## RESPONSE TO REQUEST FOR ADDITIONAL INFORMATION

### APR1400 Design Certification

Docket No. 52-046

**RAI No.:** 490-8599  
**SRP Section:** 12.03-12.04 – Radiation Protection Design Features  
**Application Section:** 12.2, 12.3-12.4, and 3.11  
**Date of RAI Issue:** 05/25/2016

**Figure 1 Dose Point Locations for Three Parallel Piping Design**

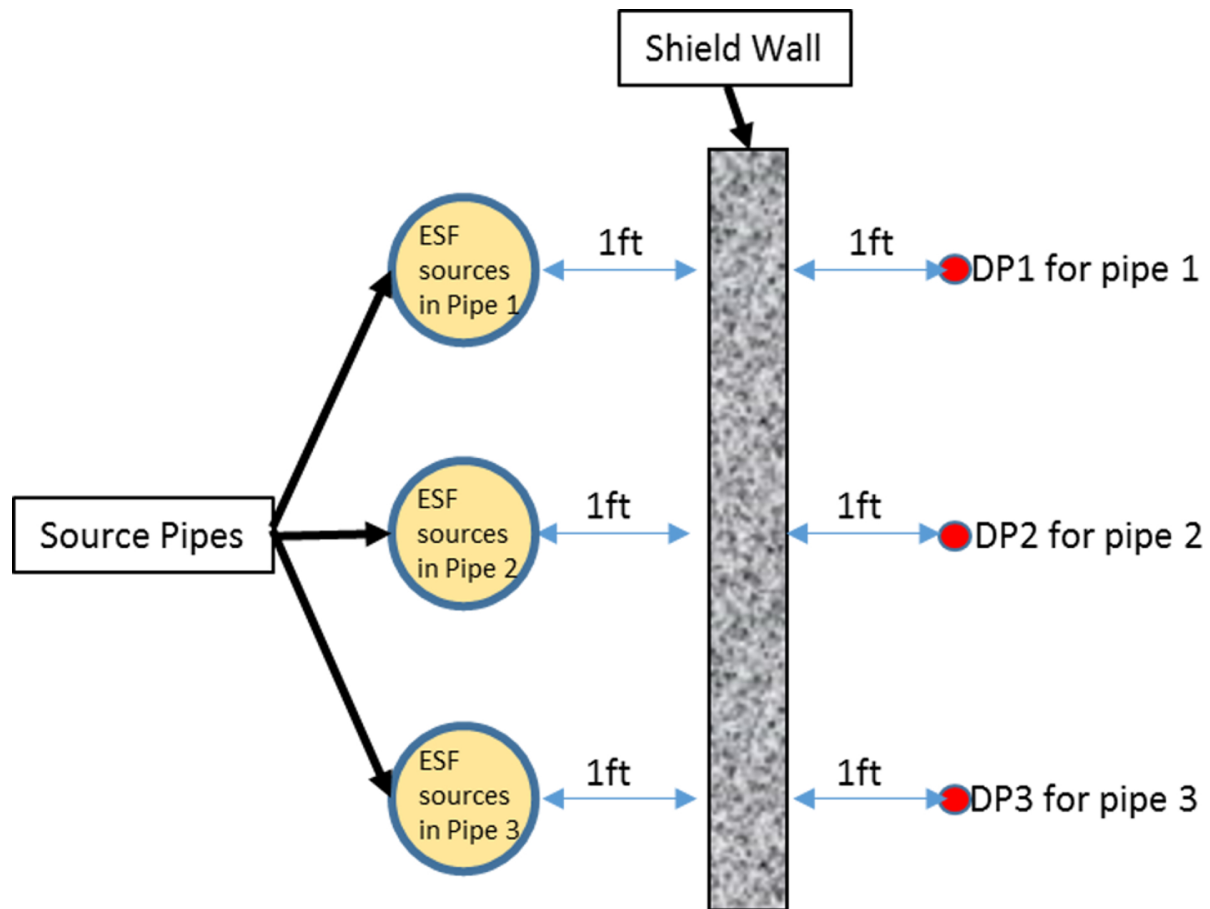
1. The mission dose rates to vital areas will likely increase as a result of result of resolving the source term issues described above and the dose values for accessing and performing activities in the Remote Control Console Room and the Remote Shutdown Room were already near the 5 rem limit. Therefore, the applicant must ensure that the methods, models, and assumptions, used for calculating the mission doses, for those mission doses near the 5 rem limit, are appropriately conservative, contain sufficient margin, and are appropriately detailed to ensure that the mission doses will be below 5 rem limit, or make appropriate changes. Specifically, the applicant should ensure that the calculations contain sufficient conservatism to account for limitations in the computer programs used to perform the calculations. The MicroShield computer code does not allow for modeling complex geometries and does not have the accuracy of MCNP computer code, but is being relied on for much of the post-accident mission dose, shielding analysis, including for areas near the 5 rem limit. Therefore, for areas near the 5 rem limit, the applicant is requested to provide additional information demonstrating that the calculations contain sufficient conservatism to ensure mission dose rates will remain below the 5 rem limit.

The simplified piping model is illustrated in Figure 1.

For the shielding design of the pipe chase, the external direct dose is calculated with a shield wall between the source piping and the dose points (DPs). The DPs are located on the opposite side of the piping, separated by a shield wall. The layout of three pipes is used as an example for clarification purposes. In this model, the three pipes are assumed to be on the same vertical plane, such that the dose rate at each DP location is maximized. Since the dose point is taken at a plane in front of the three pipes, the individual dose rate at each dose point is calculated by the summation of all 3 source points. The calculation of the shield wall thickness is based on the total dose from the summation of the 3 sources. This calculation method for the determination of the shield wall thickness is therefore conservative.

The source summation method discussed above uses direct external dose of the three dose points. The direct dose at right angle far exceeds that from incidental angles. Hence this direct and summation method has more than enough margin to offset the use of the MicroShield software as a simplified calculation tool, as opposed to the use of more complex tool such as MCNP software.
